UNITED STATES PATENT AND TRADEMARK OFFICE

APPLICATION NO.	FILING DATE	FIRST NAMED INVENTOR	ATTORNEY DOCKET NO.	CONFIRMATION NO.
10/816,000	04/02/2004	James Vogeley	4209-26	7279
23117	7590	04/25/2006		
NIXON & VANDERHYE, PC 901 NORTH GLEBE ROAD, 11TH FLOOR ARLINGTON, VA 22203			EXAMINER RODRIGUEZ, WILLIAM H	
			ART UNIT	PAPER NUMBER
			3746	
DATE MAILED: 04/25/2006

Office Action Summary

DETAILED ACTION

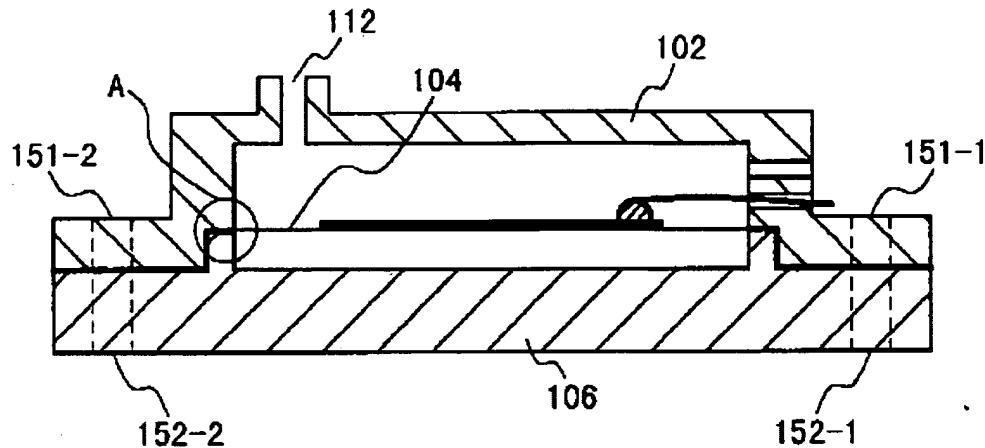
5. Claims 1, 7 and 35 are rejected under 35 U.S.C. 102(b) as being anticipated by **Bishop et al.** (US 6,071,088).

With respect to claims 1 and 35, **Bishop** teaches a pump 50 comprising: a pump body for at least partially defining a pumping chamber 18; a piezoelectric actuator 112, 212 situated in the pump body and responsive to a drive signal for pumping fluid; a drive circuit 42 which produces the drive signal and a power supply 14. **Bishop** teaches that the computer 42 serves as the drive circuit. See particularly cl. 6 ll. 36-46; cl. 8 ll. 26-30 and Figure 3.

With respect to claim 7, since **Bishop** has the same structure as claimed, it is inherent that **Bishop's** device would be able to perform the recited method steps. See particularly cl. 6 ll. 36-46; cl. 8 ll. 26-30 and Figure 3.

Fig. 1 PRIOR ART

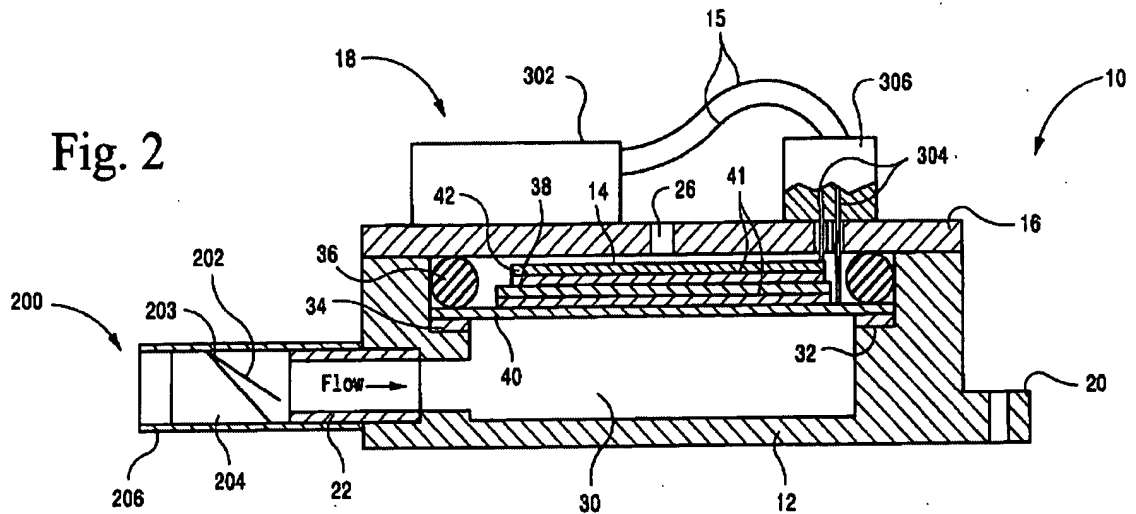
6. Claims 1, 7 and 35 are rejected under 35 U.S.C. 102(b) as being anticipated by **Kameyama et al. (US 6,104,127)**.

With respect to claims 1 and 35, **Kameyama** teaches a pump (cl. 1 ll.34-35) comprising:
a pump body for at least partially defining a pumping chamber; a piezoelectric actuator 104
situated in the pump body and responsive to a drive signal for pumping fluid; a drive circuit (cl.
1 ll. 67) which produces the drive signal, and a power supply (not shown but inherent in order to
provide power to the drive circuit). See particularly Figure 1.

With respect to claim 7, since **Kameyama** has the same structure as claimed, it is inherent that **Kameyama**'s device would be able to perform the recited method steps. See particularly cl. 1 ll.34-35, cl. 1 ll. 67 and Figure 1.

F I G. 1

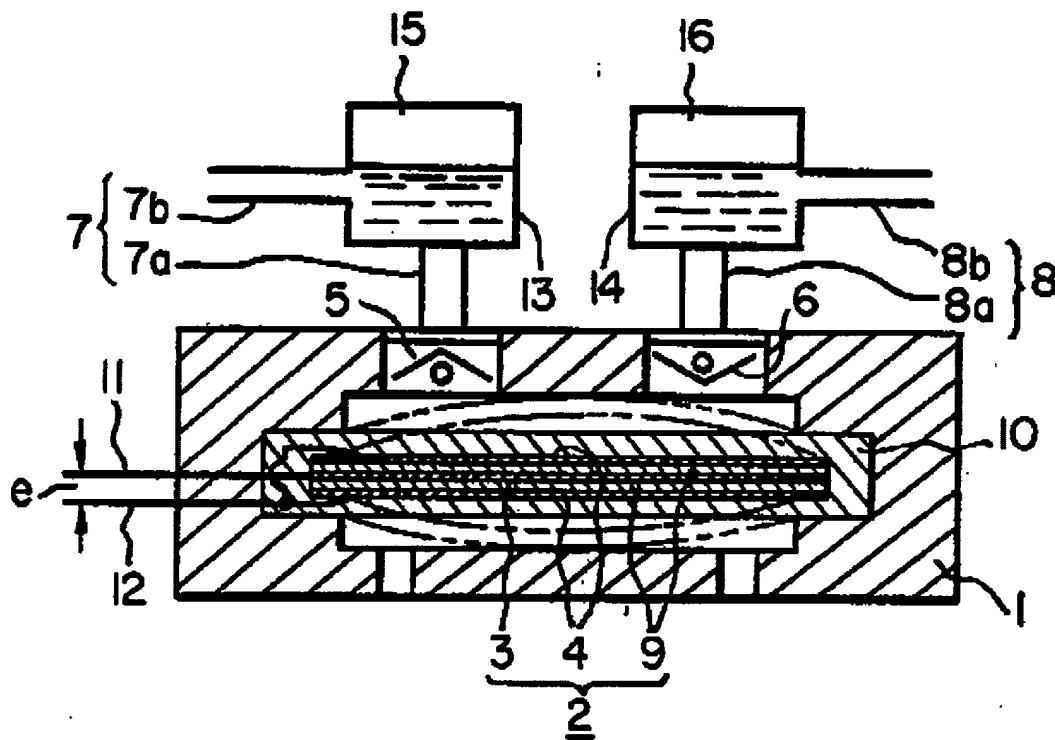
9. Claim 23 is rejected under 35 U.S.C. 102(b) as being anticipated by **Okuyama et al.** (US 4,939,405).

Okuyama teaches a pump comprising: a pump body 1 for at least partially defining a pumping chamber; a piezoelectric actuator 2 situated in the pump body and responsive to a drive signal for pumping fluid; a drive circuit (3, 4, 9, 11, 12) which produces the drive signal, wherein the piezoelectric actuator 2 forms part of the drive circuit. See particularly cl 1 ll. 22-32 and Figure 1.
